PITTSFIELD TOWNSHIP PLANNING COMMISSION AGENDA

**Preliminary Site Plan and Conditional Use Review
For
Pittsfield Township, Michigan**

File No.:	CSPA 20-05 and CUP 20-02
Applicant:	Zippy Auto Wash / Corey Weaver
Plan Date:	April 8, 2020
Location:	3952 Bestech (Lot 2) – Southwest corner Carpenter and Bestech
Zoning:	I, General Industrial
Action Requested:	Preliminary Site Plan and Conditional Use Approval

**BUILDING
 FLOOR PLAN
 & ELEVATIONS**
 SHEET NO.

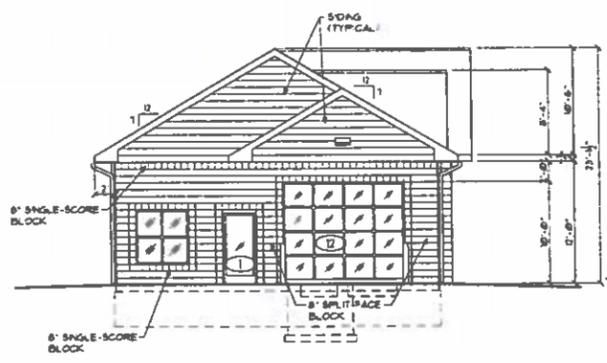
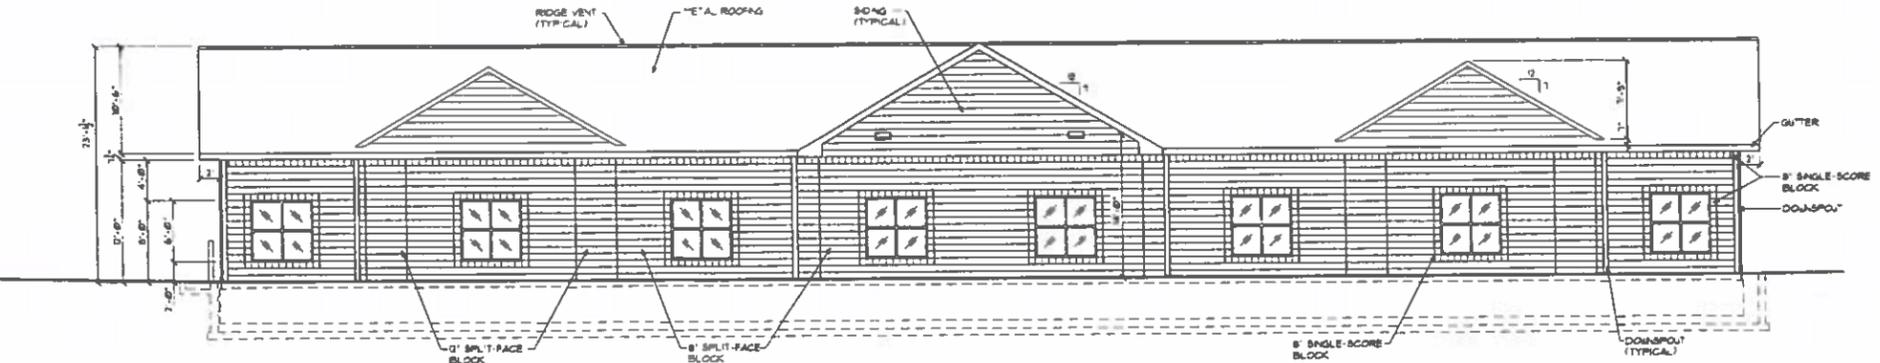
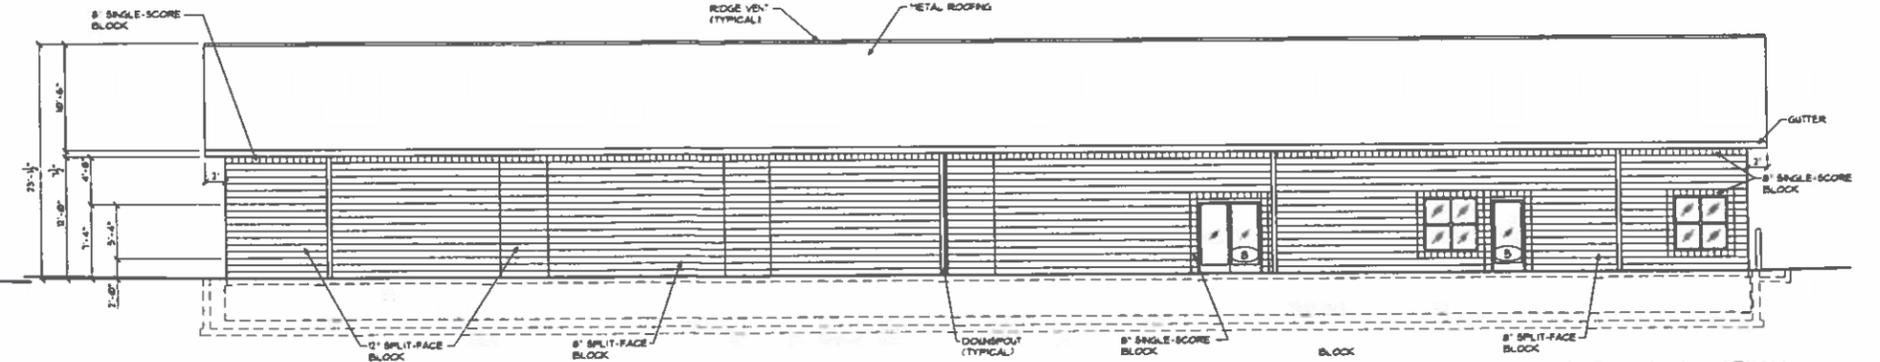
Floor plans and elevations are provided on Sheet A-1. Exterior materials will include split-face block and metal roofing. Applicant has provided color renderings.

Figure 1. Wetland Locations (*Drainage Area Plan*, source: giffels webster). Approximate project property is shown in red and wetland areas are indicated in green.

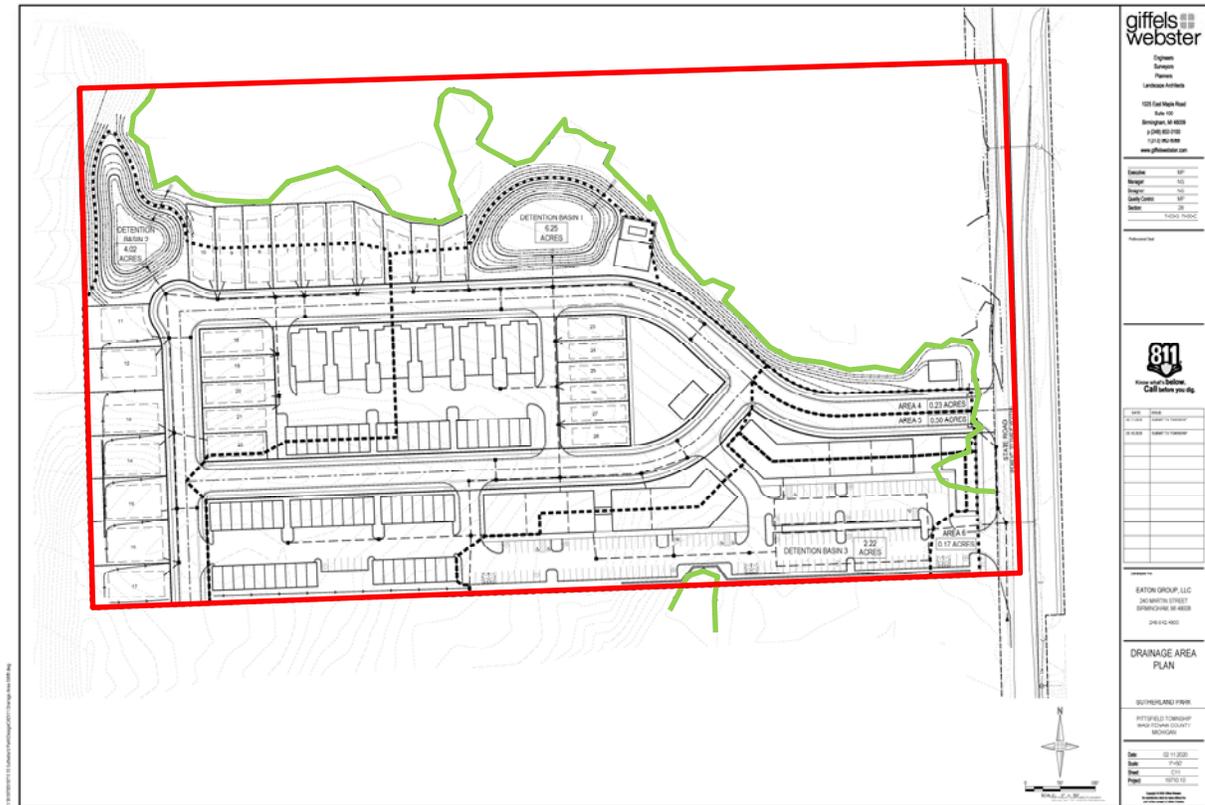
2. The Master Plan (Sheet L1) indicates that there are 6.78 acres of existing wetlands on the site however the individual wetland areas do not appear to be quantified on the Plan (i.e., square feet or acres). The existing wetland areas shall be quantified on subsequent site plan submittals.
